**To:** Development Permit Panel

**File:** DP 18-837117

**Re:** Application by W. T. Leung Architects Inc. for a Development Permit at  
6333 Mah Bing Street

Project No.: 18-037117  
 Sheet No.: PLAN #49  
 L-1.9  
 JUL 07 2020

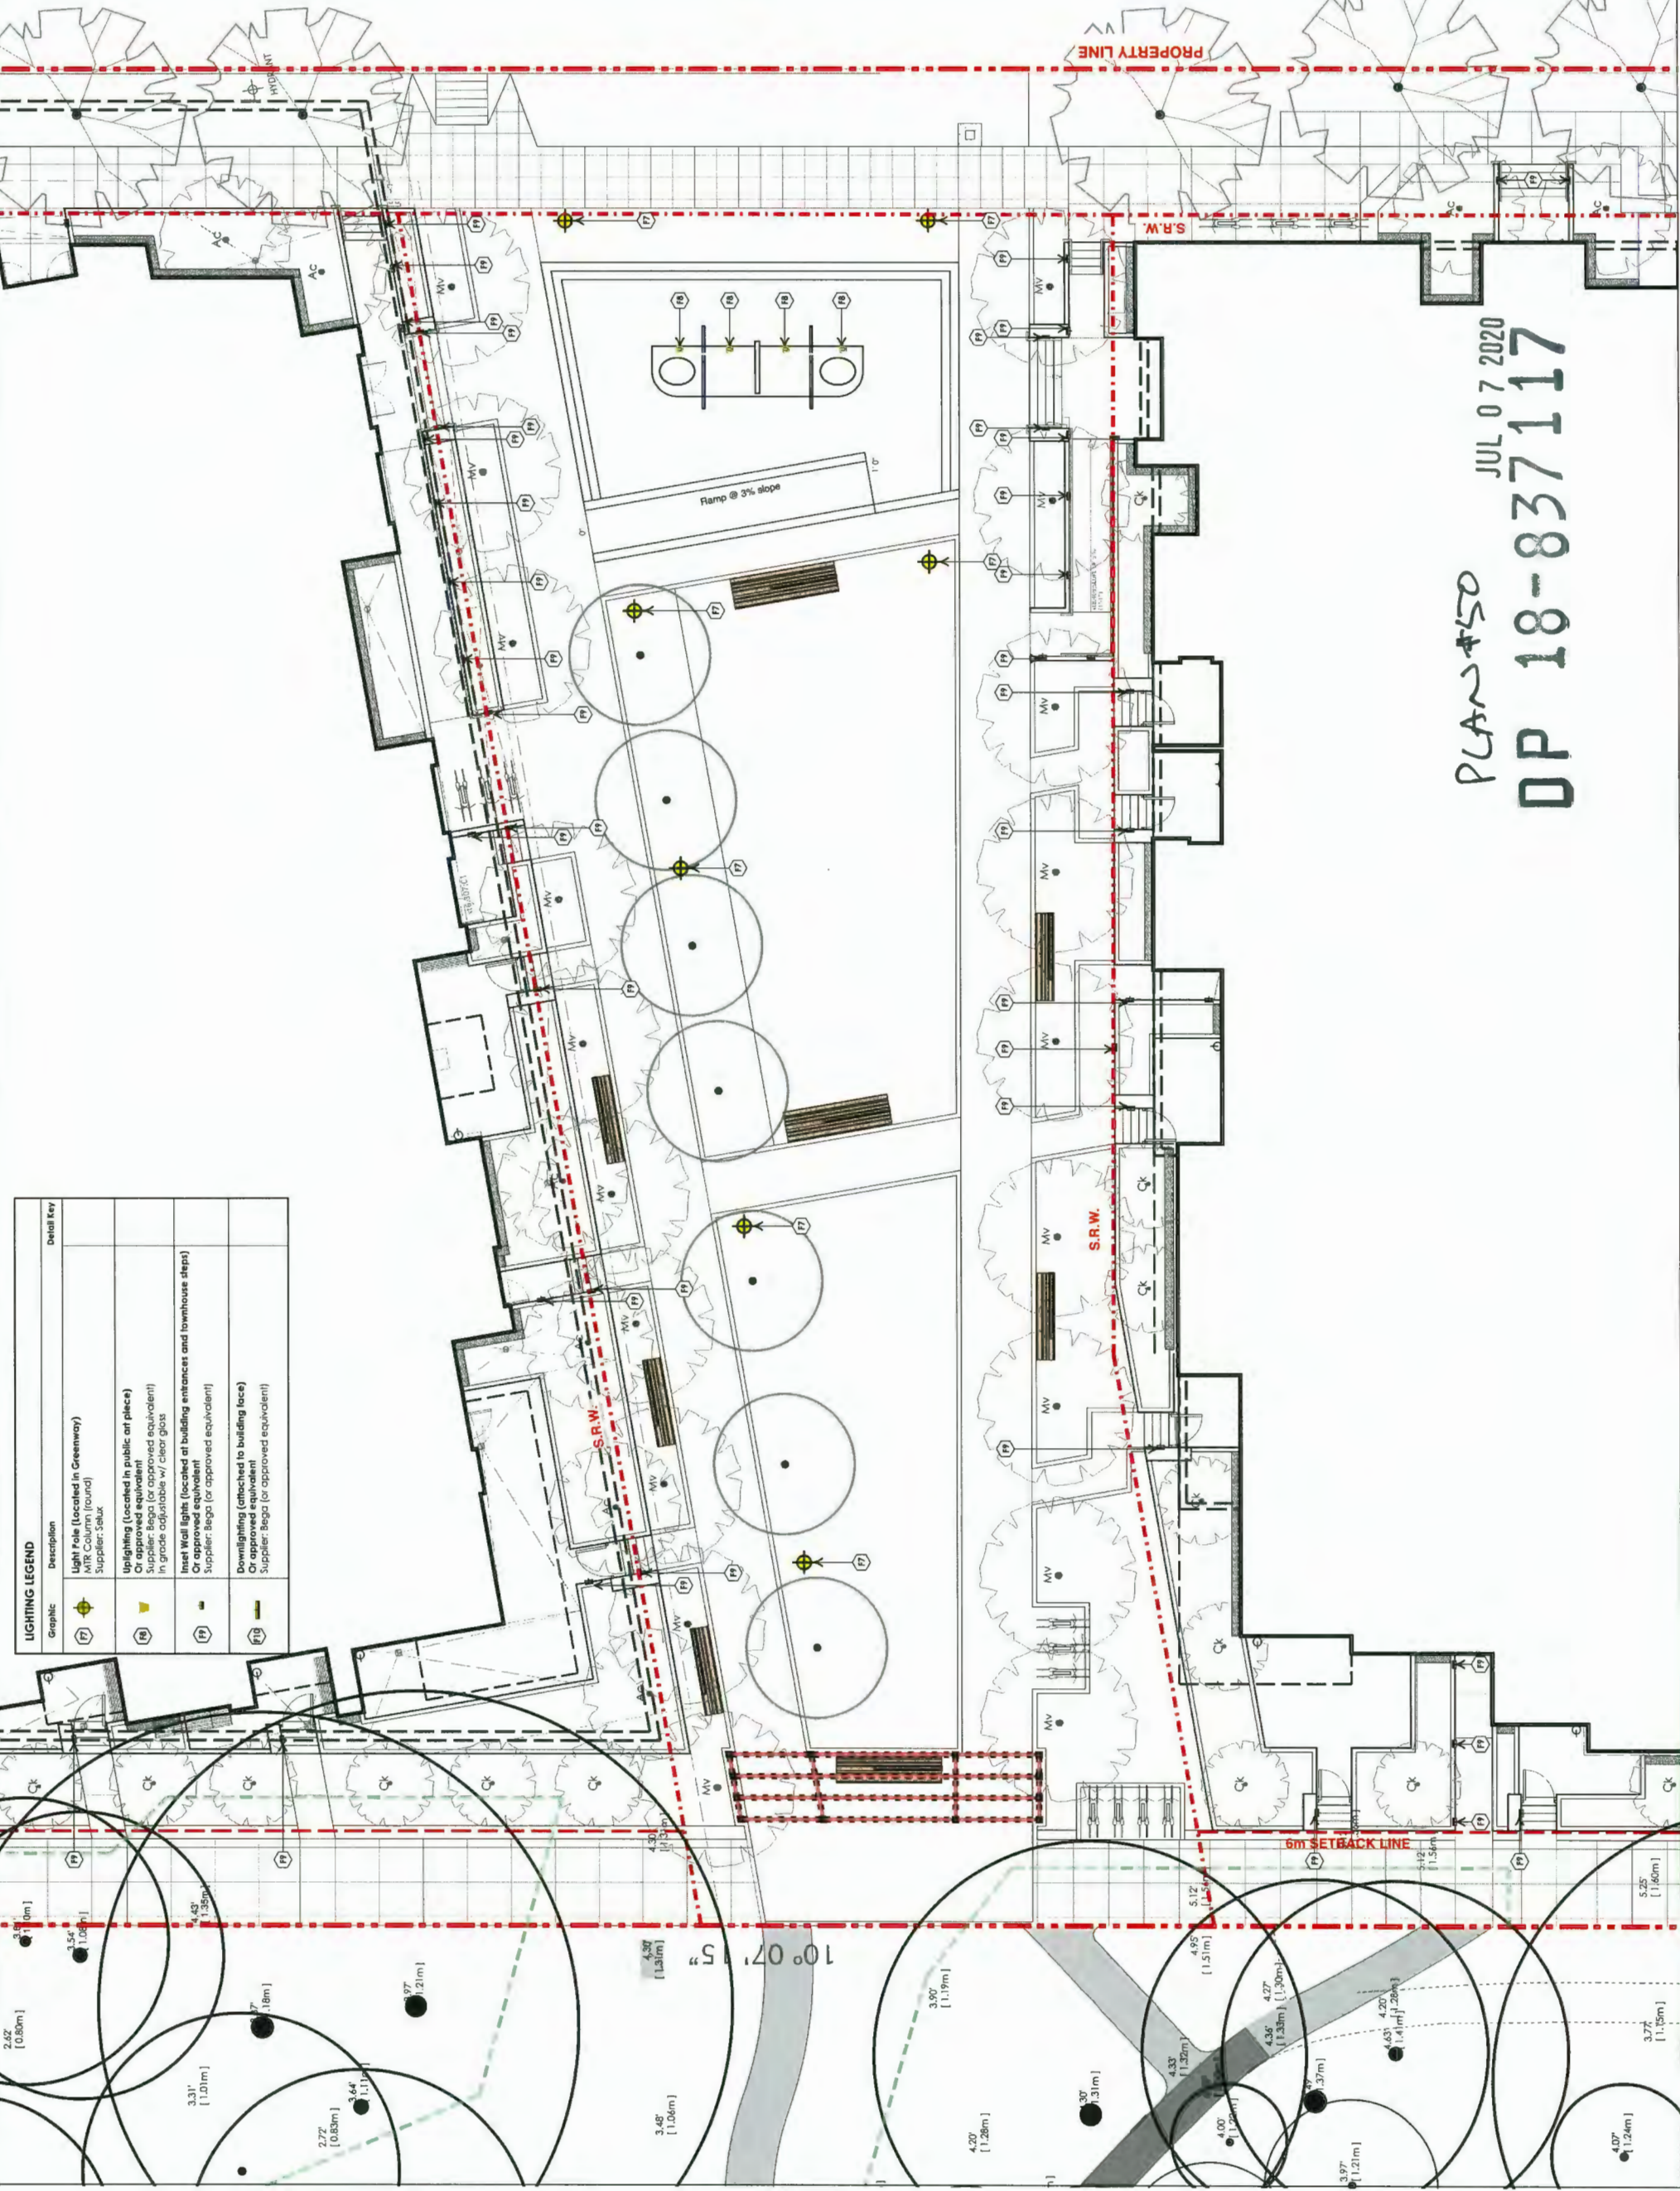
- appreciate the current approach to break down the massing of the south façade of Tower E; however, consider further breaking down the mass on the pedestrian level at grade through further articulation, e.g. introducing patterns or another colour for the brick material to provide visual interest to pedestrians; also ensure adequate lighting on the south edge to address potential CPTED concerns;

- review the proposed lighting strategy for the greenway and consider a lighting strategy which balances addressing potential CPTED issues and avoiding light disturbance to neighbouring residences and light pollution; consider installing a greater number of low level lighting to ensure a more even distribution of lighting in the greenway;

***WTLA: Brick material provided at south elevation between Terra Cotta at Mah Bing and Glass Panel at park. Separate Lighting Plan has been developed and lighting specs included on landscape drawing L1.9***

***WTLA: Separate Lighting Plan has been developed and lighting specs included on landscape drawing L1.9***
